**SITE PLAN REVIEW**

**Subject: 20030 Mack (Eastside Dermatology) Site Plan Review**  
Parcel ID: 012-04-0026-000  
Site Plan Review #1  
Zoning: RO-1 – Restricted Office

# EASTSIDE DERMATOLOGY

20030 MACK AVE.  
GROSSE POINTE WOODS

*Rendering with the proposed changes, prepared by Stucky Vitale*

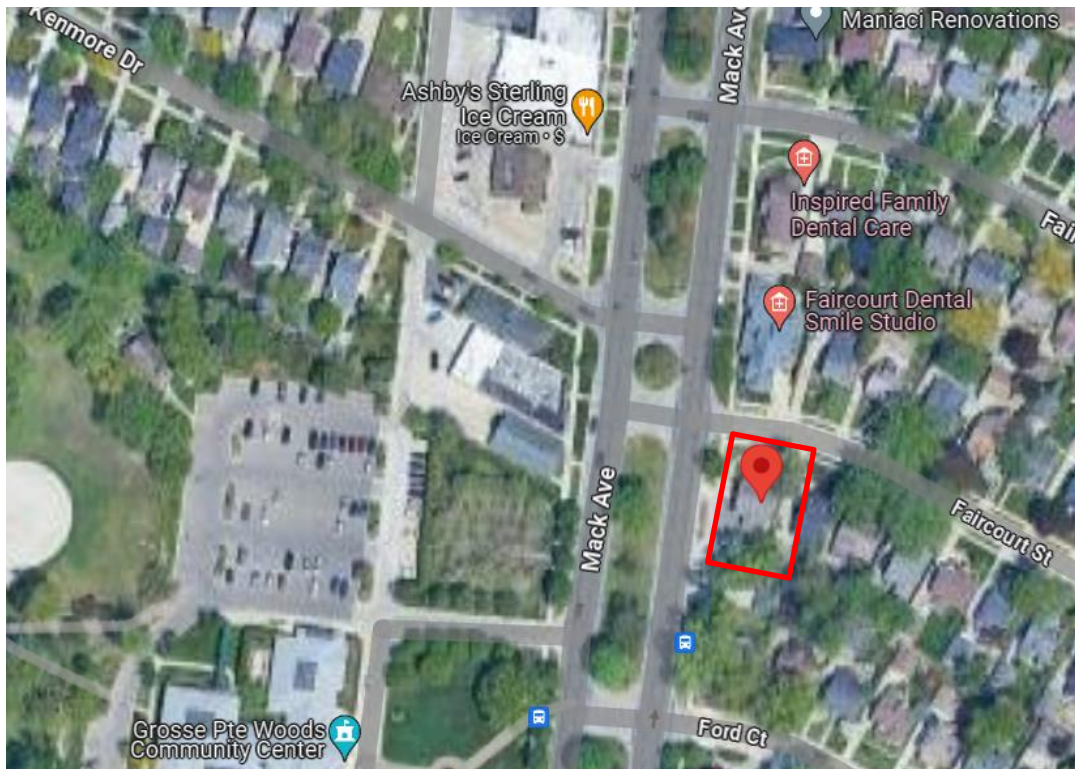
At the meeting, the applicant should provide colored renderings of the existing building and its proposed addition as well as offer substantial evidence that 6 off-street parking spaces can meet the parking demand.

**SITEPLAN OVERVIEW - PROPOSED**  
 1  
 A001  
 1/8" = 1'-0"

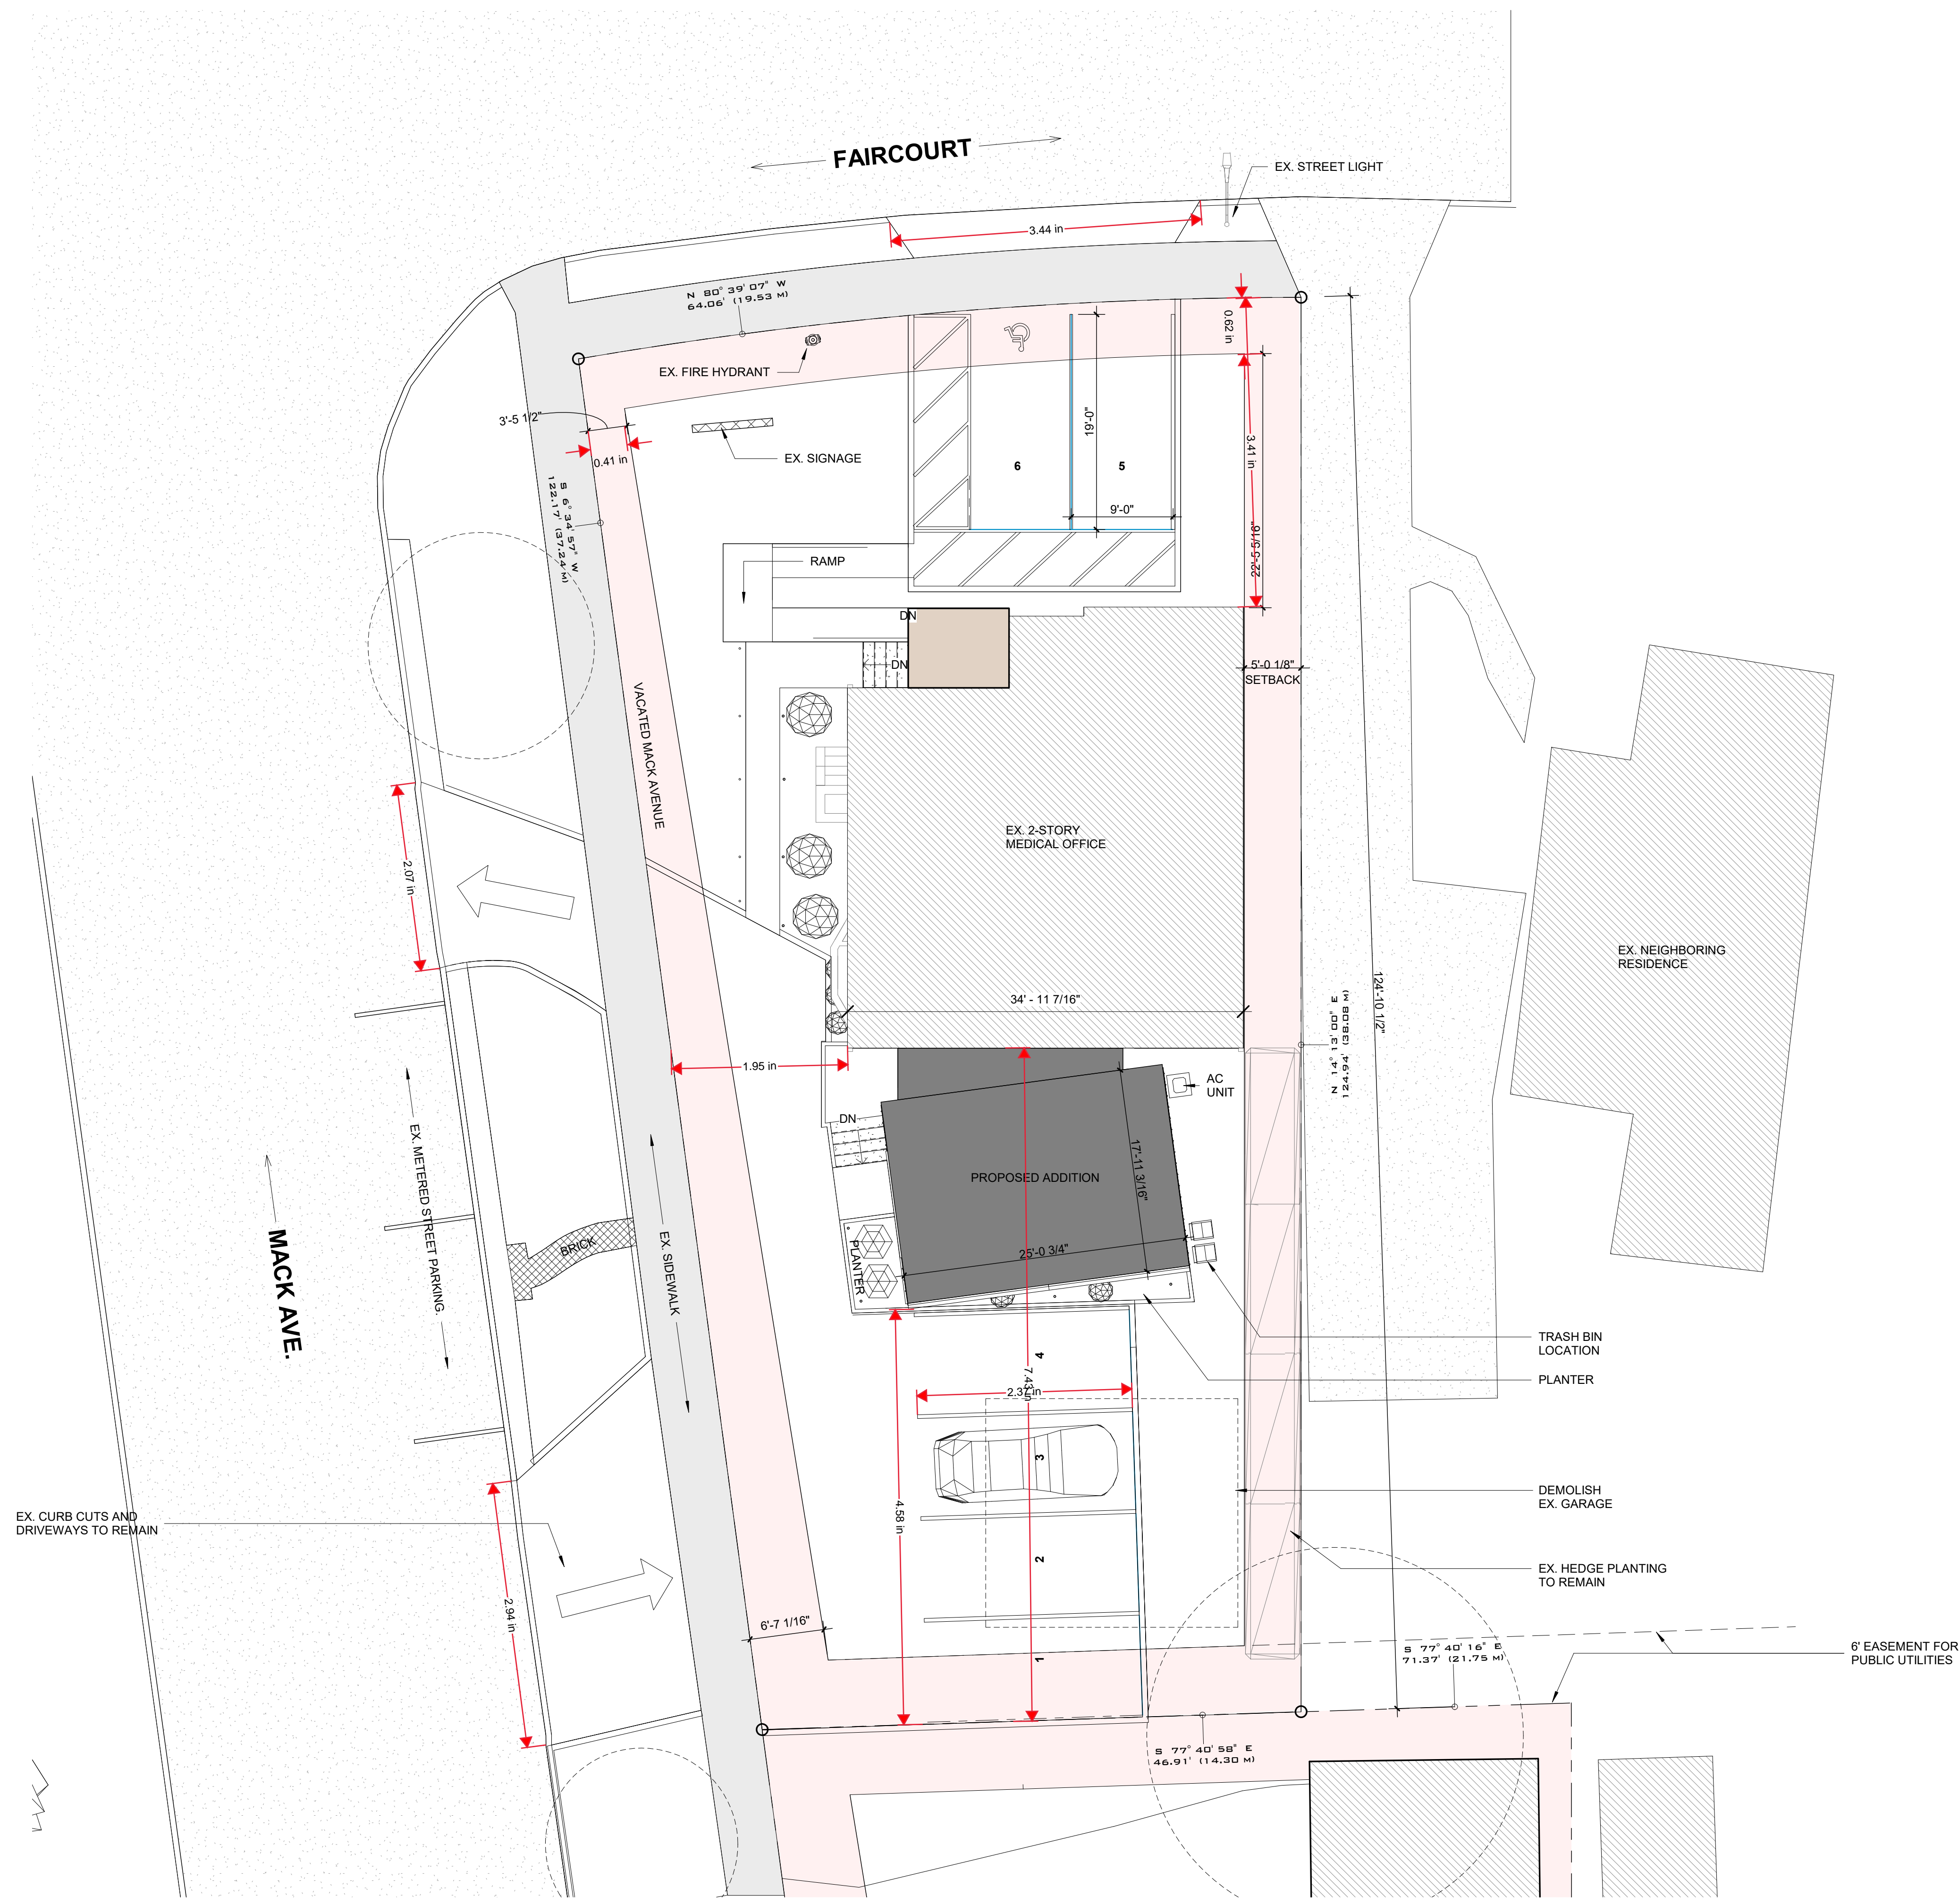
**Findings: While it appears dimensional requirements may be met, the Applicant must clarify the setbacks and height of the building by clearly labeling it within the site plan. This should be updated in future site plan revisions and submissions.**

Additionally, Section 50-5.3(U) states that parking lots shall be provided with traffic lane markings to indicate entrances and exits, and to provide for the safe and orderly movement of vehicles. **These required traffic lane markings are depicted on the plans, however, the Applicant must note that they will be painted onto the existing ingress/egress.**

Parking spaces are required to be a minimum of 9' by 19'. **The parking spaces south of the building should be labeled to ensure the spaces meet the minimum requirements.**

Given that the parking lot and maneuvering lane abuts the sidewalk, the design should meet the requirements of Section 50-5.3 (N). **A barrier should be added for the portion of the parking-maneuvering lane that abuts the public sidewalk to prevent cars from extending over or encroaching upon the public sidewalk. Such barrier shall be not in excess of eight inches in height, nor less than six inches in height and shall be firmly attached or anchored to such parking lot; and such barrier shall be of such type as to prevent vehicles using such parking lot from interfering with or jeopardizing pedestrian traffic on such public sidewalk.**

Additionally, the off-street parking areas is adjacent to a residential property as must comply with the requirements of Section 50-5.3(Q). There must be a setback of at least 10 feet between the parking areas and adjoining residentially zoned parcel. A 2-4 foot ornamental masonry wall or dense shrubbery screen is required. The proposal plans to preserve the dense shrubbery, which blocks the parking spaces with enough space to preserve the clear vision area for cars existing both parcels.

With the introduction of additional parking spaces on site, the Applicant must ensure that nearby properties are not affected by potential nuisances such as headlight glare. **We recommend landscaping be introduced to the site wherever possible, especially along the west side of the parking spaces along Faircourt St that can be viewed from the public right of way. Appropriate landscaping options would include large evergreen shrubs or trees. In addition, all mechanical equipment (A/C units, transformers, generators, meters, etc.) must be screened by evergreen landscaping.**

EXTERIOR ELEVATIONS N/S

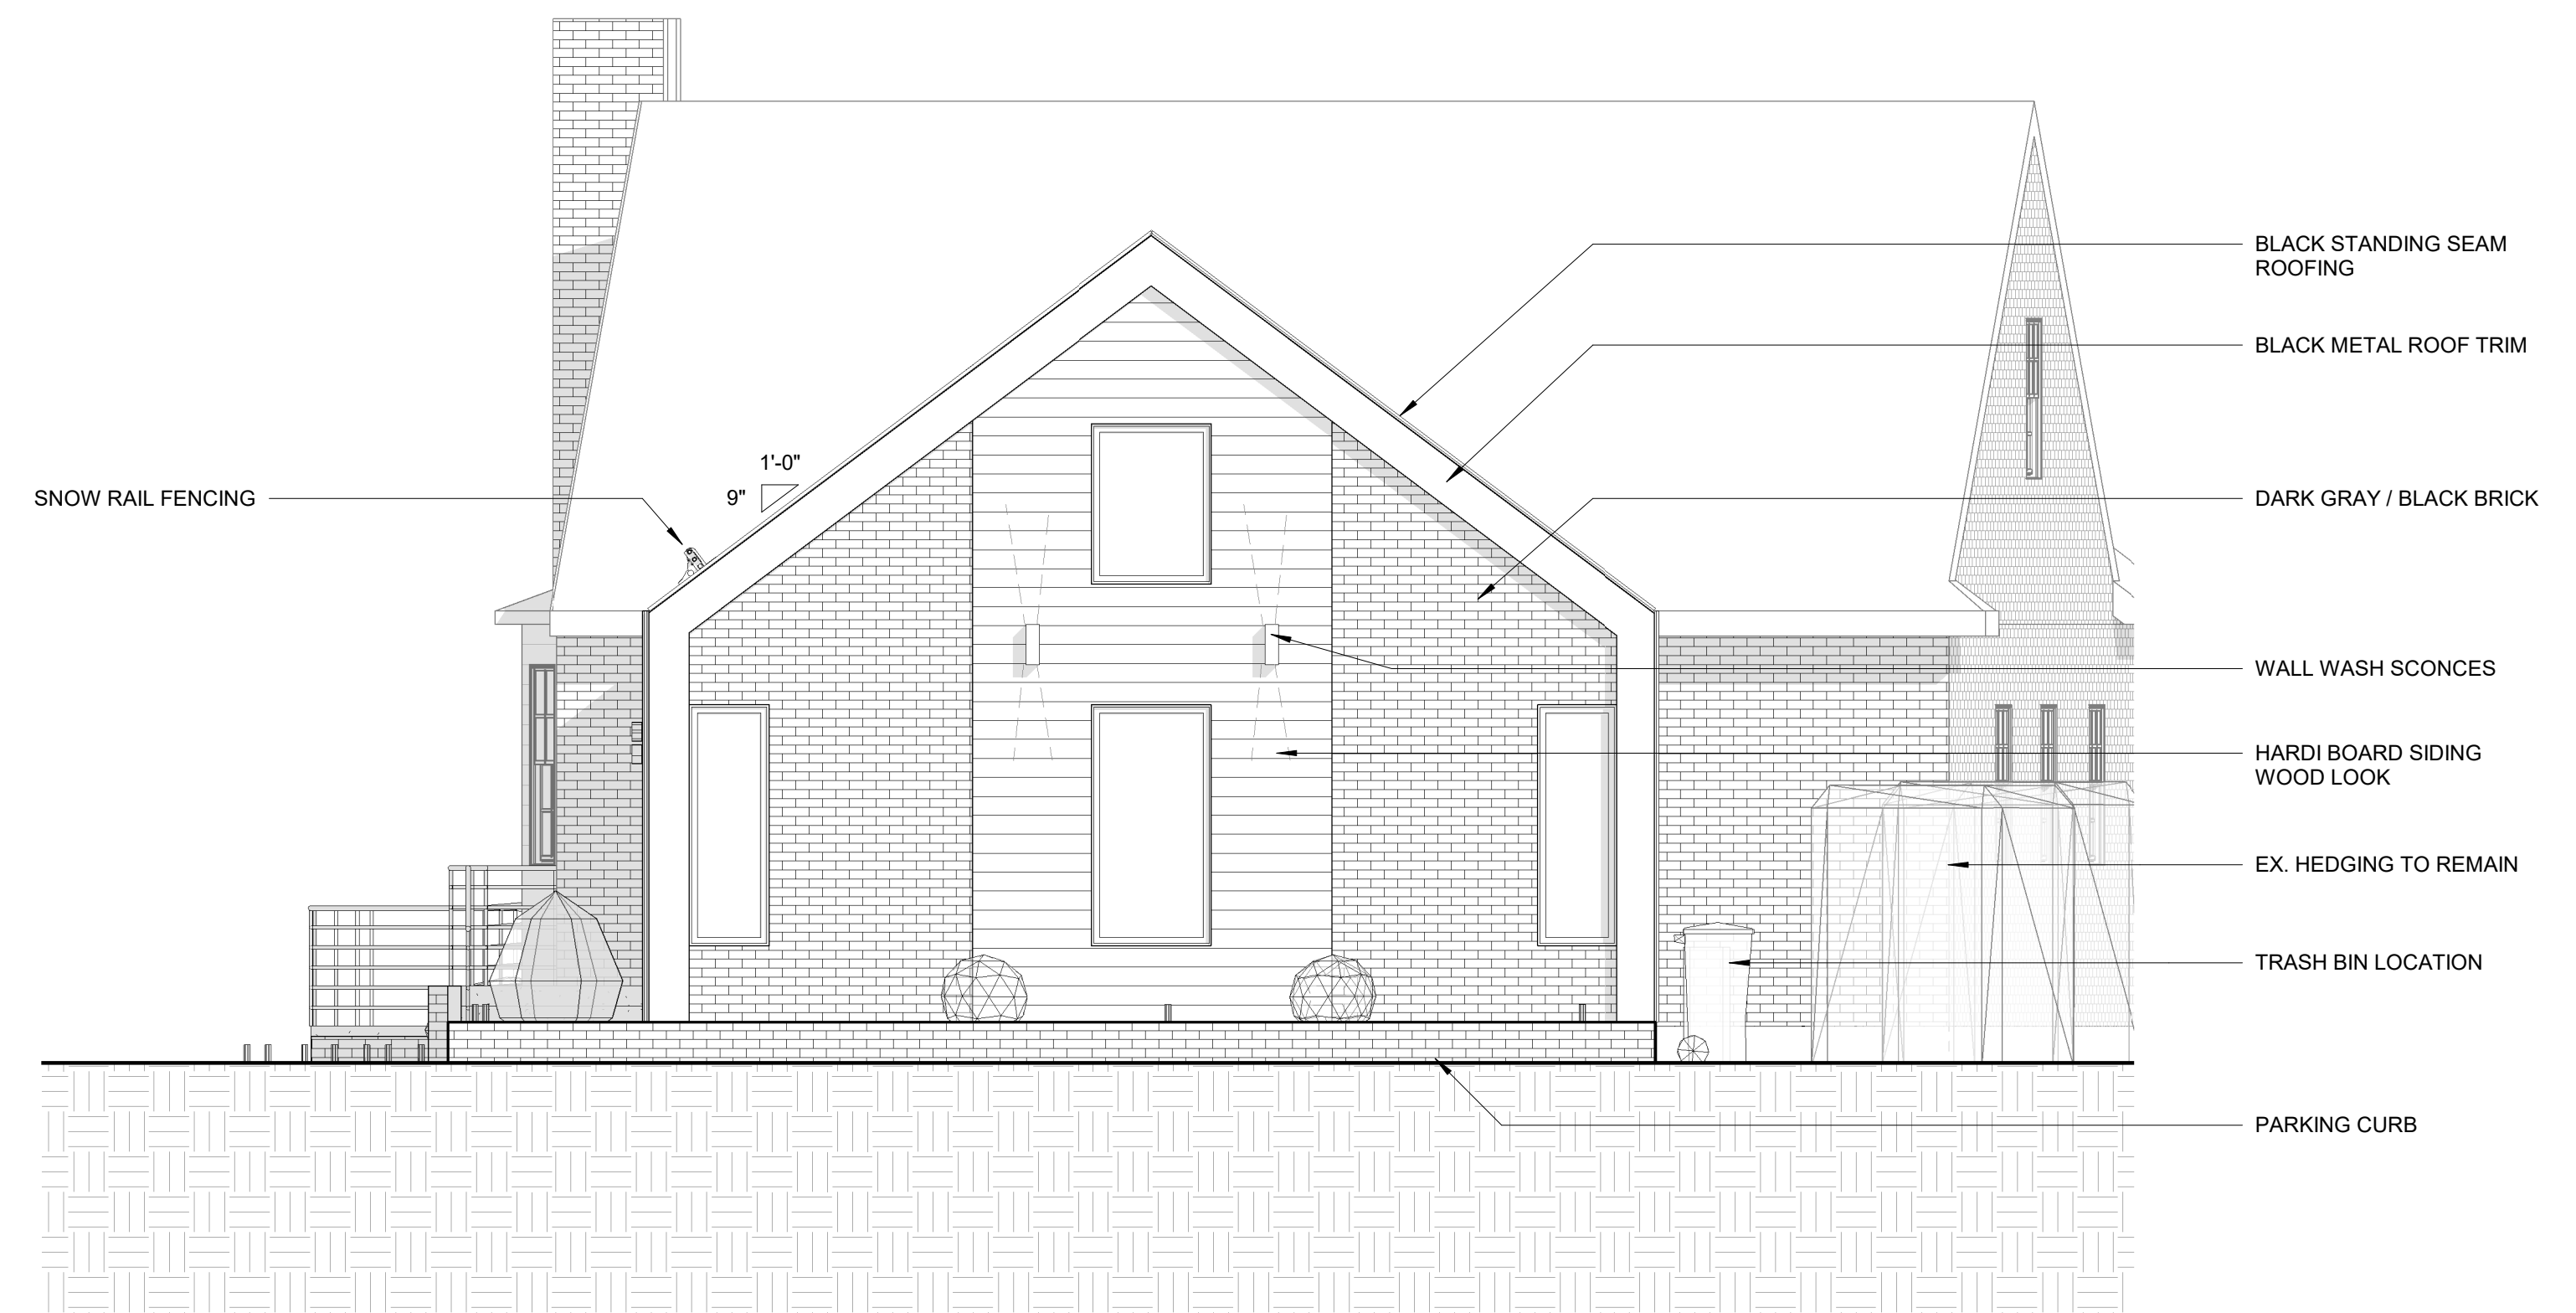
The elevations provided by the Applicant illustrate that the building addition will be primarily composed of dark gray / black brick with a horizontal board siding as an accent. This will be paired with wall wash sconces, a black metal roof trim, and black standing seam roofing. The existing building is composed of white painted brick, which the Applicant intends to maintain.

Per Section 50-5.18 of the Zoning Ordinance, new construction, renovations, remodeling, or exterior building alterations in the RO-1 restricted office district shall be in conformance with approved design standards. While the architectural design and current colors of the existing building conform to these standards, it is currently unclear whether the proposed addition conforms in terms of color and architecture. **To provide the Planning Commission with a clear picture of the proposed addition and how it relates to the existing building, the applicant must provide colored renderings and elevations. In addition, per Section 50-6.1(G)(7) of the Zoning Ordinance, the applicant must bring samples of the material to be used on the building’s exterior to the Planning Commission meeting.**

The applicant has proposed two wall wash sconces on the south elevation of the new addition. **The applicant must provide additional lighting information such as cut sheets, wattage, existing lighting, and/or a photometric plan to determine compliance with Zoning Ordinance standards.**
